# ATTACHMENT A

DATE: May 4, 2022

**TO:** Design Review Commission  
**FROM:** Jia Liu, Associate Planner  
**SUBJECT:** SC21-0046 – 628 Cuesta Drive

PROPOSED  
FLOOR PLAN -  
LEVEL 2

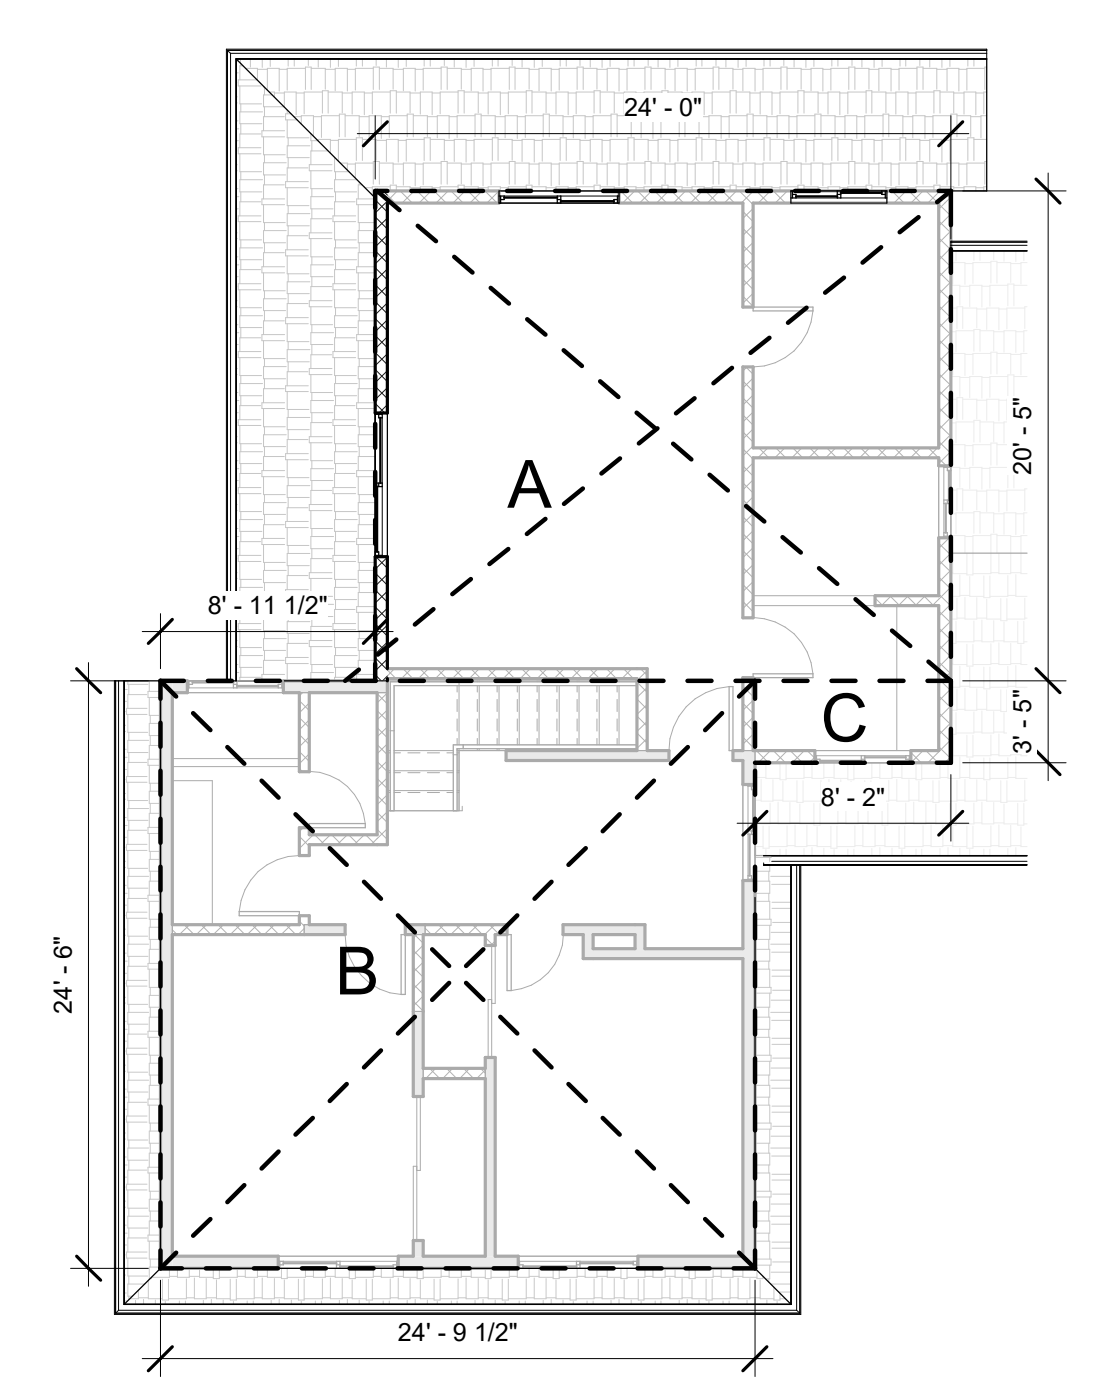
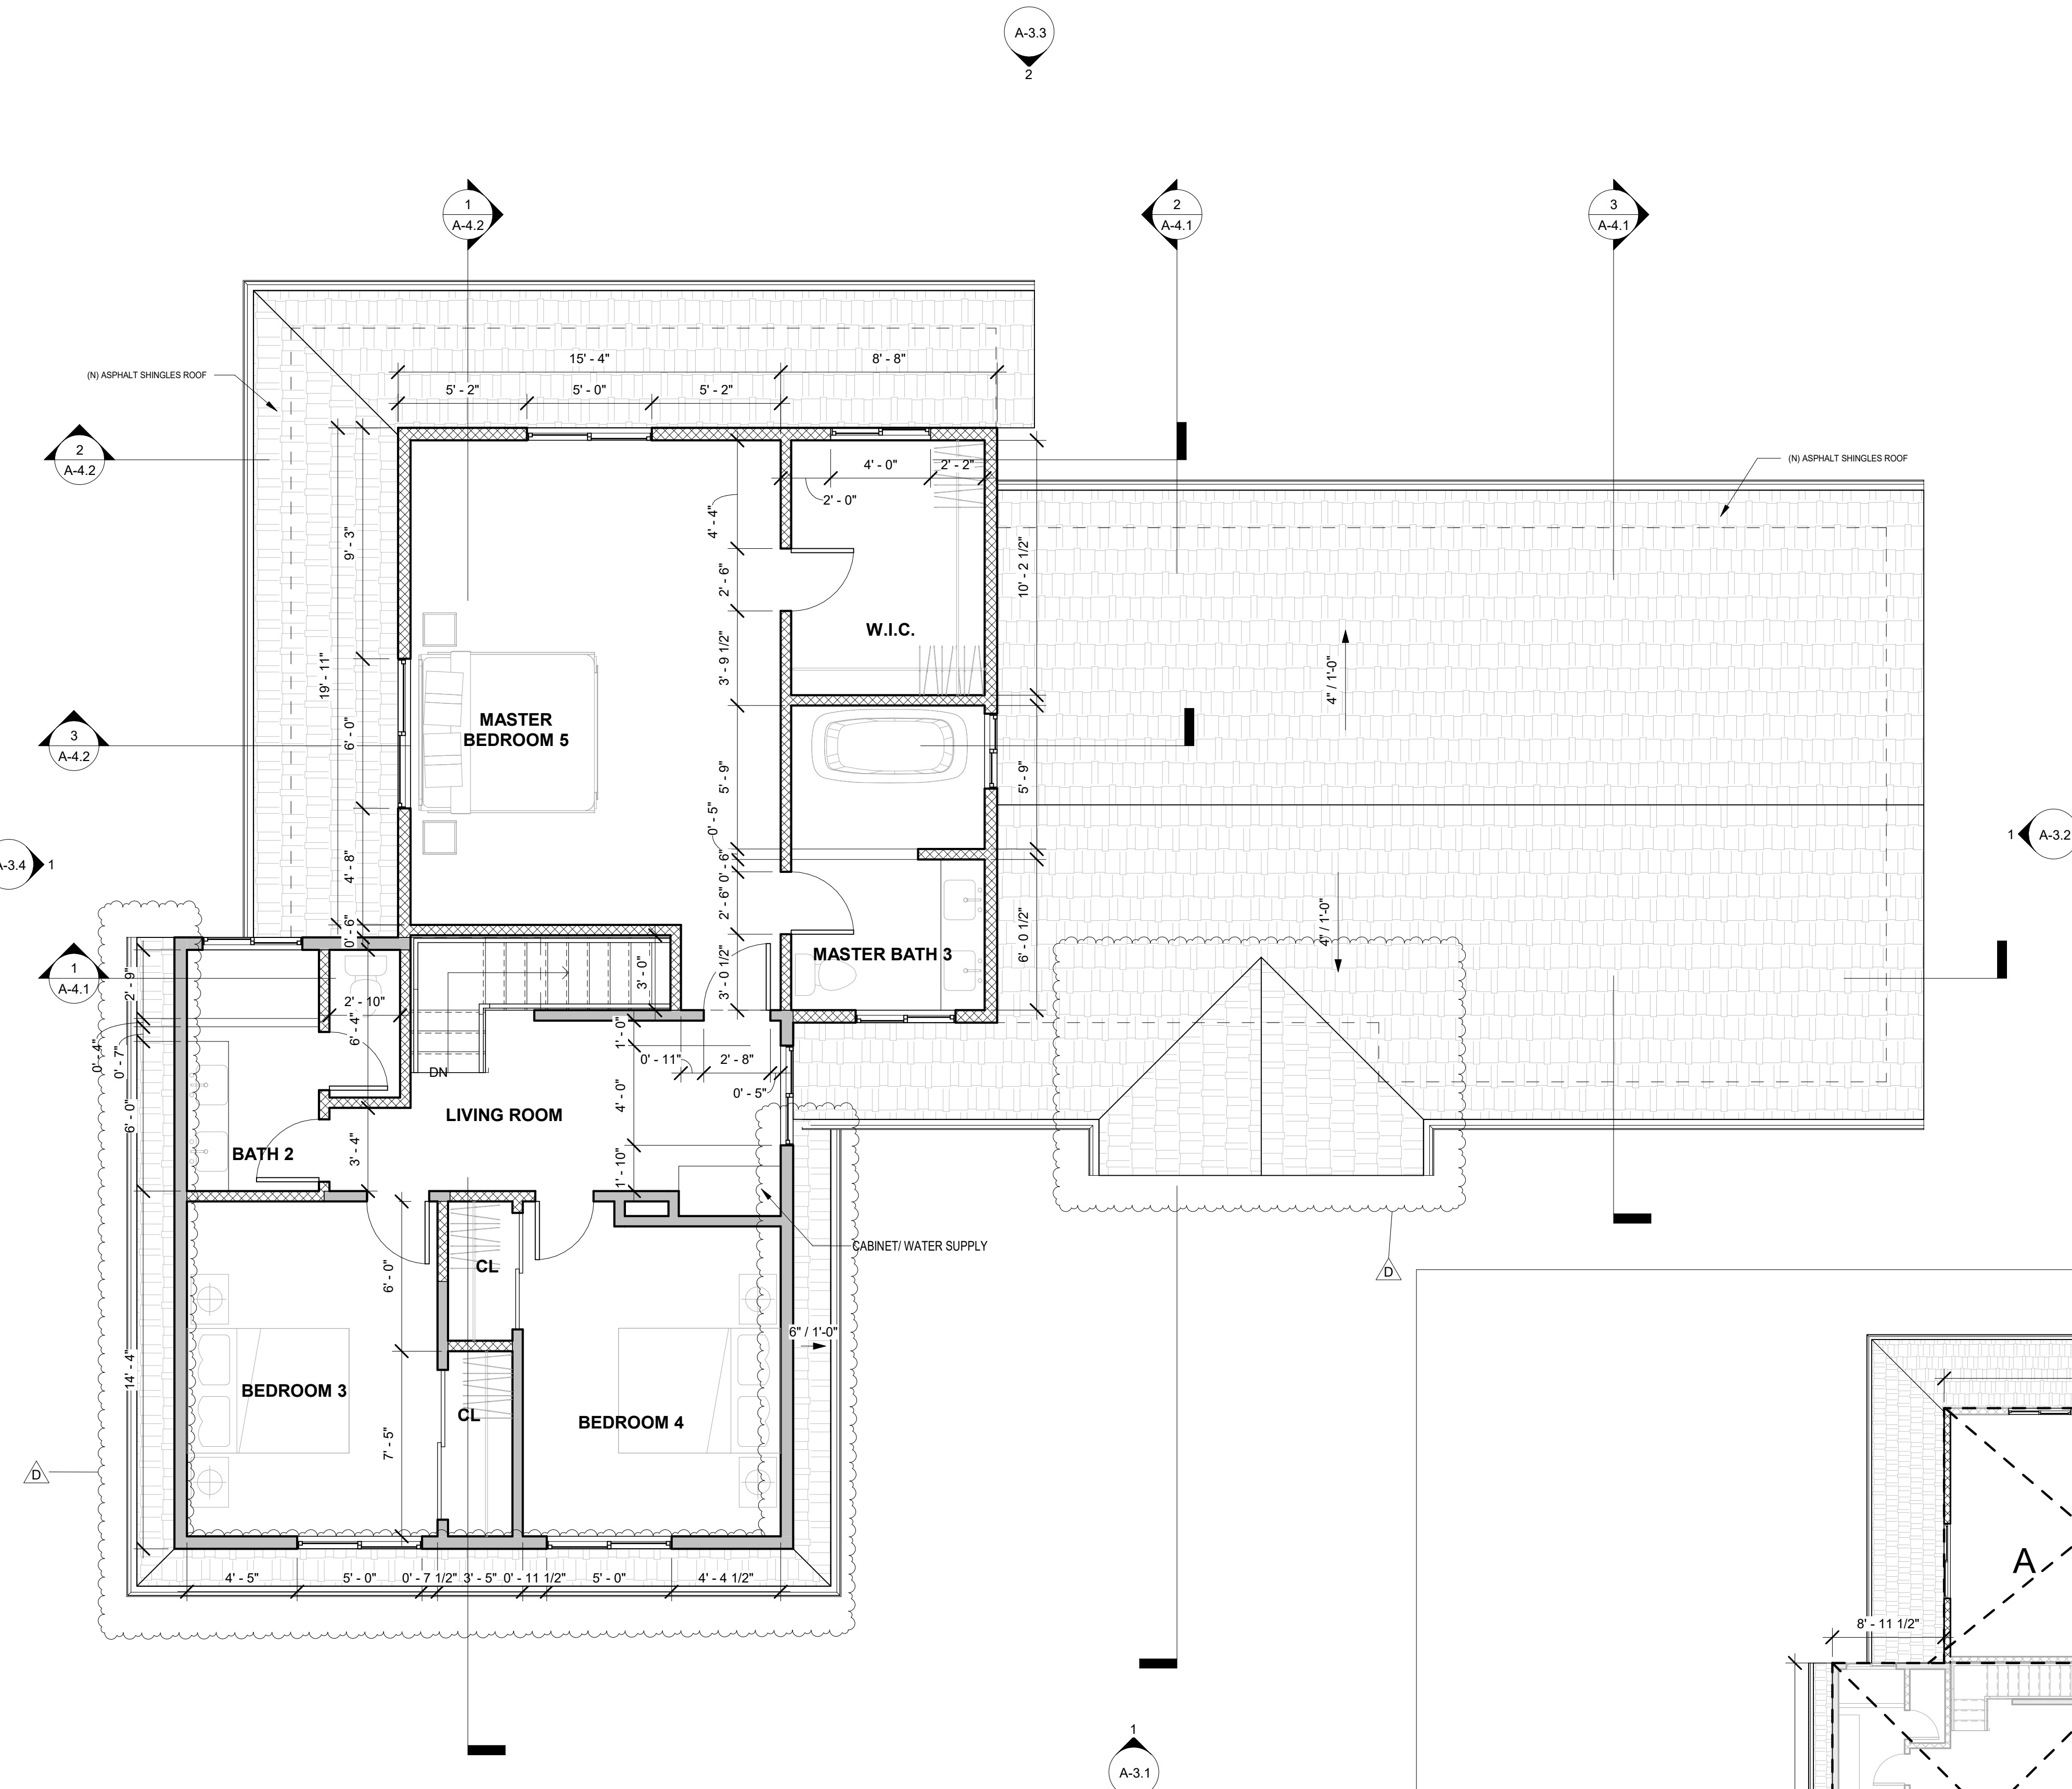
- Applicant shall reconsider the rear facing windows to reduce the visual impact as well as light impact to the rear neighbors fronting Arboleda Drive; and

5. The master bedroom window at the second story was changed from six feet in width by five feet in height with two-foot, six-inch windowsill height to five feet in width by four feet in height with three-foot, six-inch sill height to reduce the privacy and light impact.
6. A full landscaping plan was updated and included in the plan set.

## EXISTING / PROPOSED ELEVATIONS

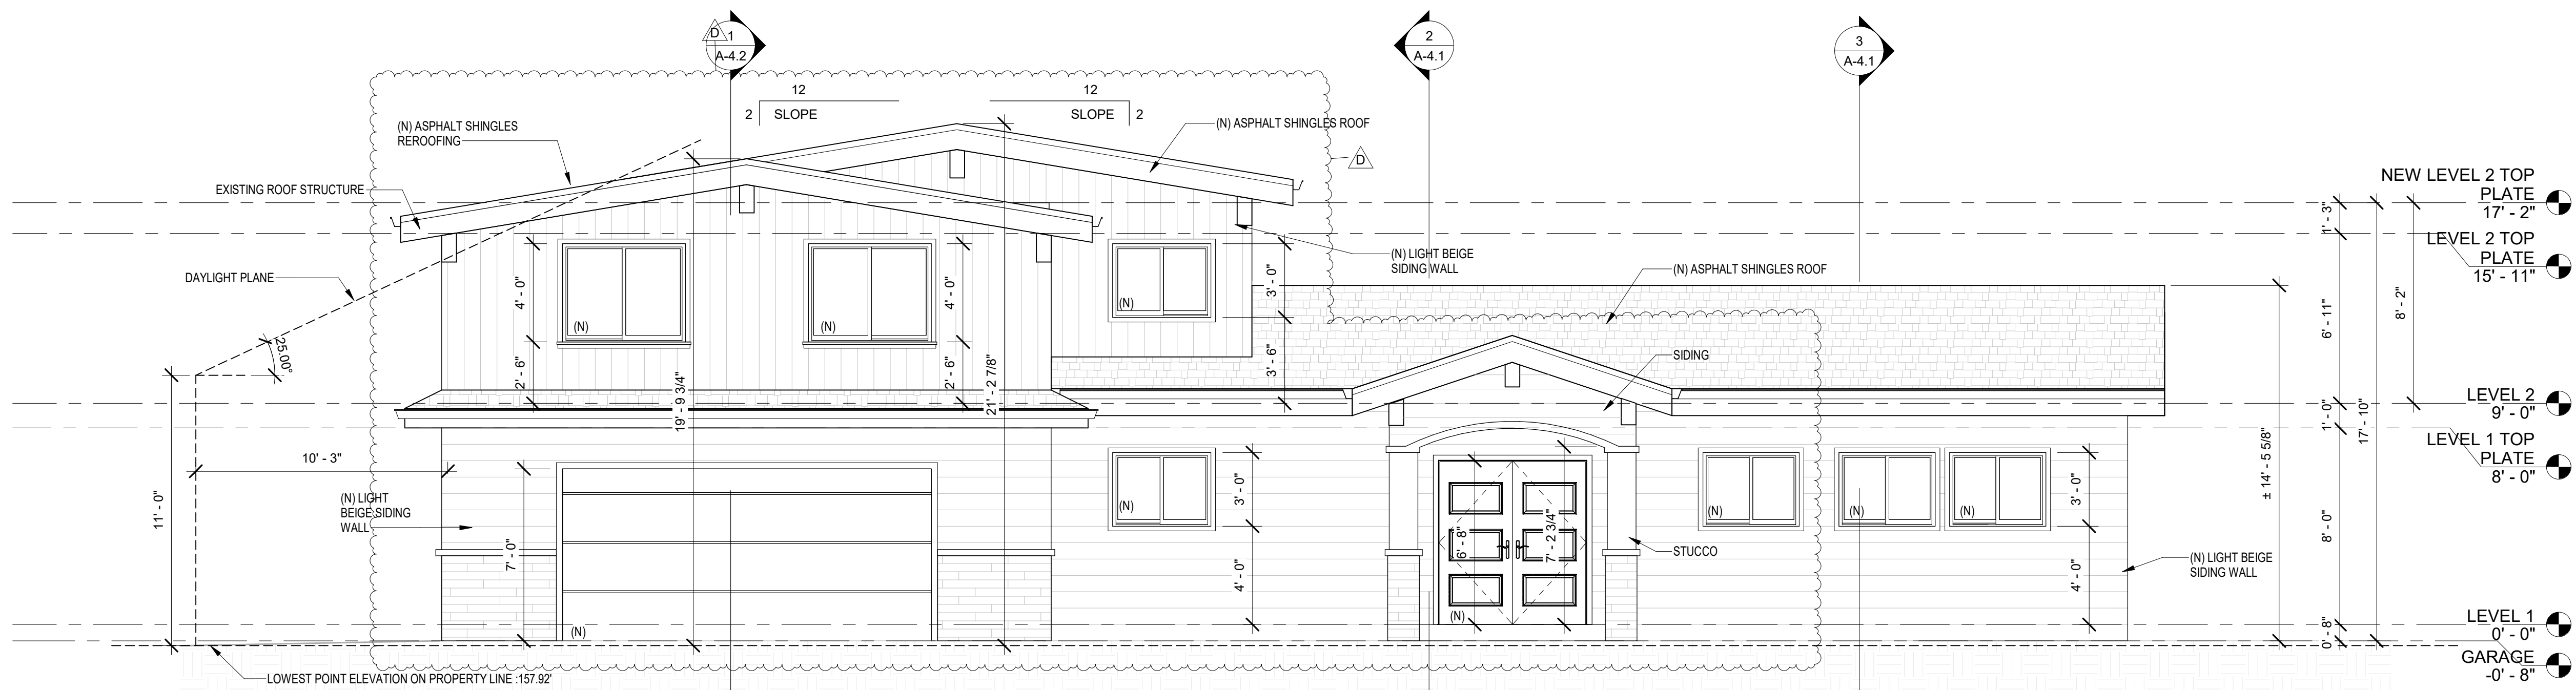
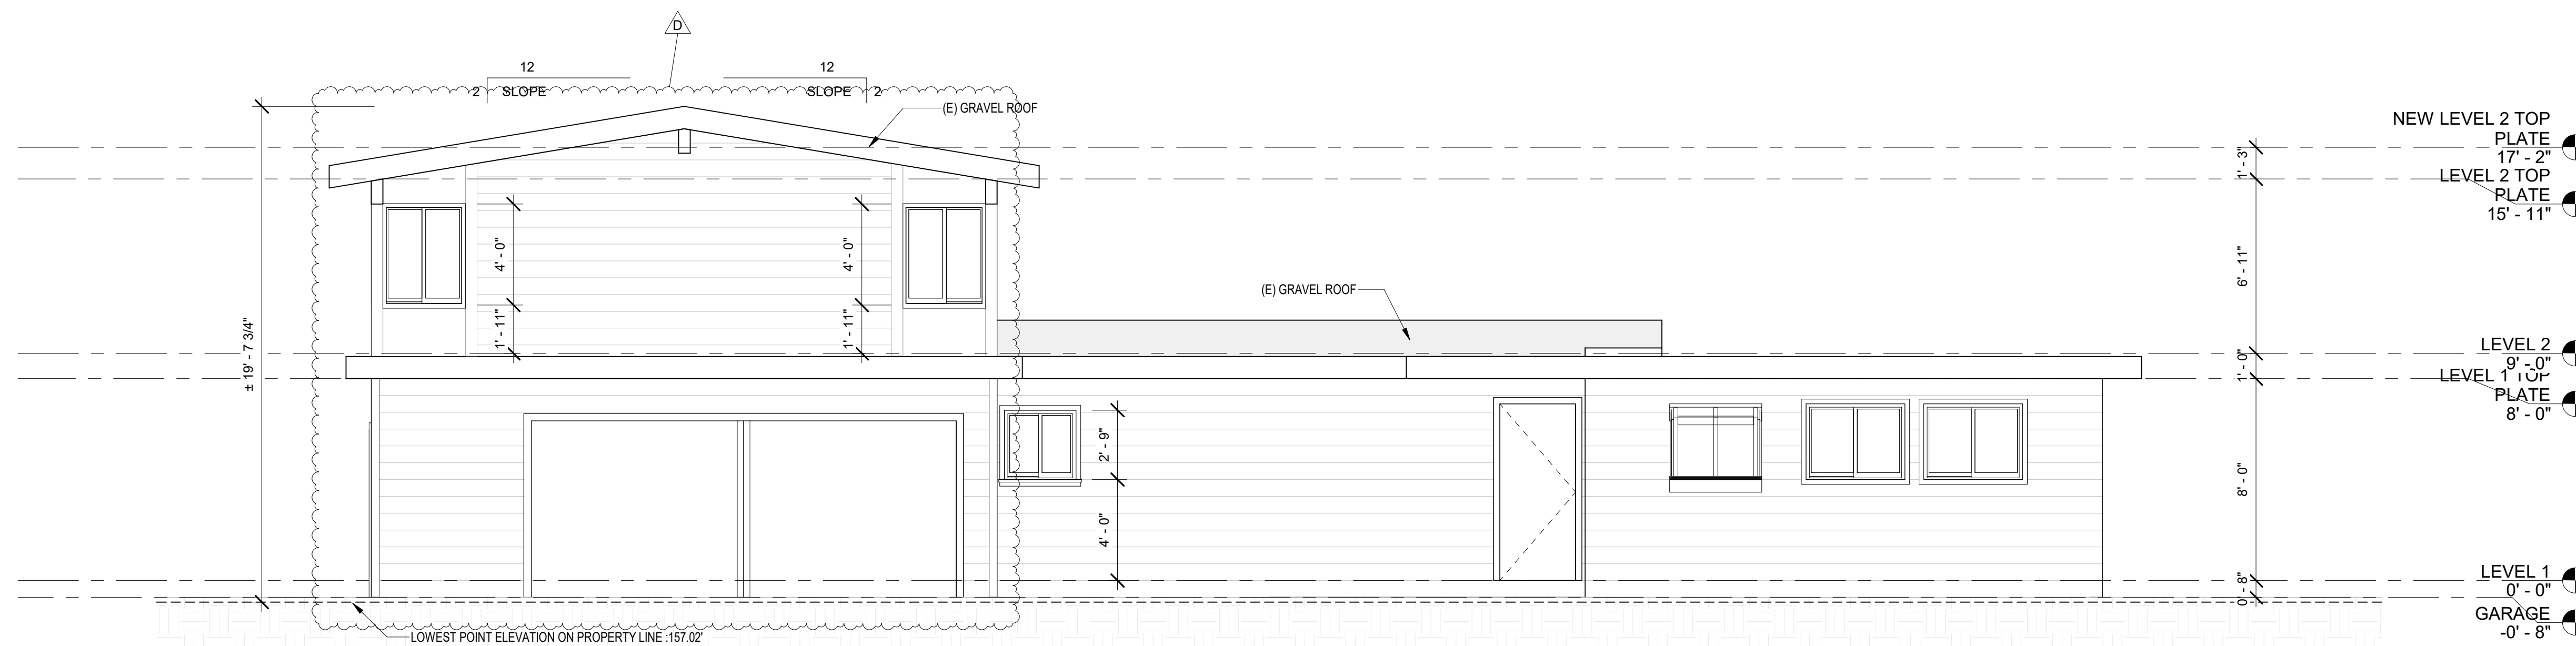
- There are discrepancies between the depicted existing elevations and the actual building elevations. Applicant shall revise the existing elevation plans to reflect the actual conditions;

1. The applicant communicated with the adjacent neighbors and provided a support letter and email responses from the adjacent neighbors to document the agreement of the current design.
2. The existing front elevation was updated to reflect the real conditions.
3. The materials board on Sheet A-6 was updated with more details.
4. Following the Section 5.4 of the Residential Design Guidelines, the applicant made the following modifications to mitigate the bulk and massing:
  - Added architectural elements including a porch to the existing entrance and roof projections between the first story and existing second story;
  - Applied distinct exterior materials including horizontal siding at the first floor with stone veneer wainscoting at the garage and vertical siding at the second floor; and
  - Centered the garage door and made the existing garage and second-story element symmetric.
